# Technical Service Bulletin

<b>GROUP</b>	<b>NUMBER</b>
<b>RECALL</b>	<b>26-01-005G</b>
<b>DATE</b>	<b>MODEL(S)</b>
<b>JANUARY 2026</b>	<b>G90 (RS4)</b>

**SUBJECT:** FALSE DETECTION OF VEHICLE IN HDA MODE – FRONT BUMPER BEAM REPLACEMENT (RECALL 030G)

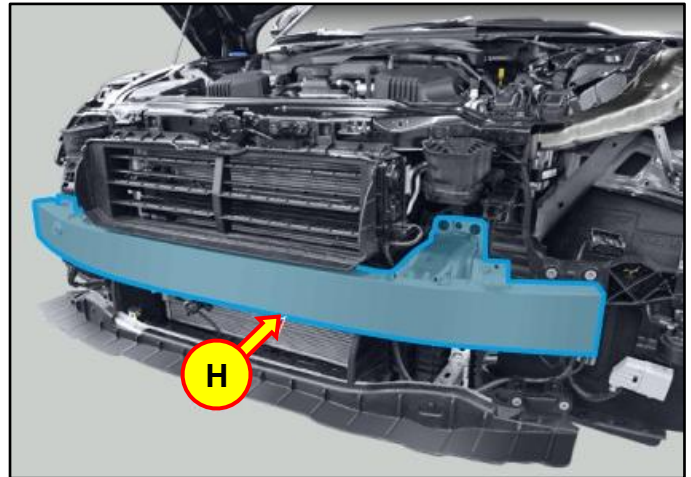
10. Install the new front bumper beam assembly (H).

Using the STUI camera function, take a photo of the new front bumper beam assembly showing the updated design change of the end caps.
